**NOTICE OF
COUNCIL ASSESSMENT PANEL MEETING**

**CITY OF MARION
COUNCIL ASSESSMENT PANEL AGENDA
FOR MEETING TO BE HELD ON
WEDNESDAY 3 APRIL 2019
COMMENCING AT 6.30PM**

2.1 9 DUDLEY CRESCENT, MARINO

2.2 5 CUNGENA AVENUE, PARK HOLME

Image 1: Picture of current wall taken from rear yard of adjacent dwelling at 11 Dudley Crescent, Marino. Reconfiguration of roof will occur, whilst extension of wall on boundary will occur to the northern part of the wall, behind current tree.

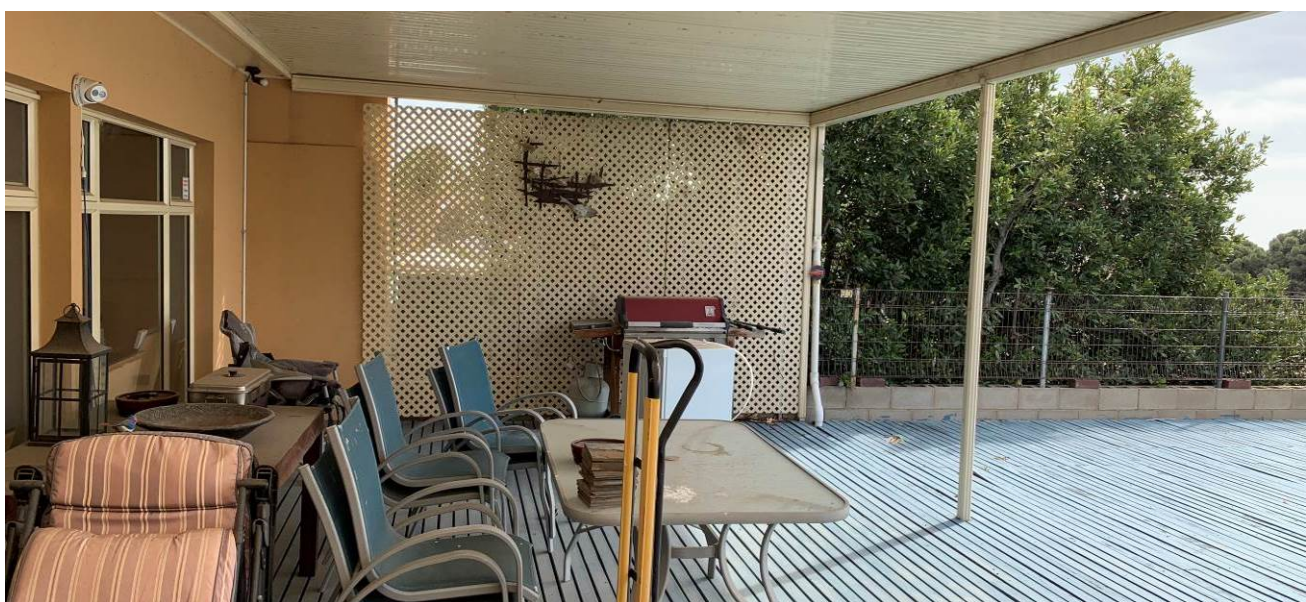
The expanse of the western façade will be most apparent from the rear yard of the adjacent allotment at 11 Dudley Crescent due to both the sloping nature of the topography and gable end nature of the proposed wall (6° gable).

Although the extent of wall on the boundary does not comply with the quantitative criteria (no greater than 8 metres in length and 3 metres in height) and no articulation to this façade has been provided, landscaping in the form of mature trees currently exist on the adjacent allotment and will assist in screening a majority of the wall extension proposed. Should the existing mature landscaping be removed, then the additional portion of wall proposed will increase the considerable expanse of wall visible when standing in the adjacent allotment's rear yard.

Therefore visual and amenity impacts associated with the height and bulk of the proposed wall are largely limited to the proposed roof design reconfiguration. Given the current visual impacts posed by the wall, and the location of existing mature landscaping, the increase in visual or amenity impacts on occupants utilising the rear yard are not considered significant to a degree where refusal is warranted. Whilst the western façade would preferably incorporate a greater level of articulation, via stepping and/or a mix of materials, given the positioning of the proposed addition in relation to

the adjacent dwelling, the potential visual impact upon the adjacent property, above what is already in existence, is not considered unreasonable.
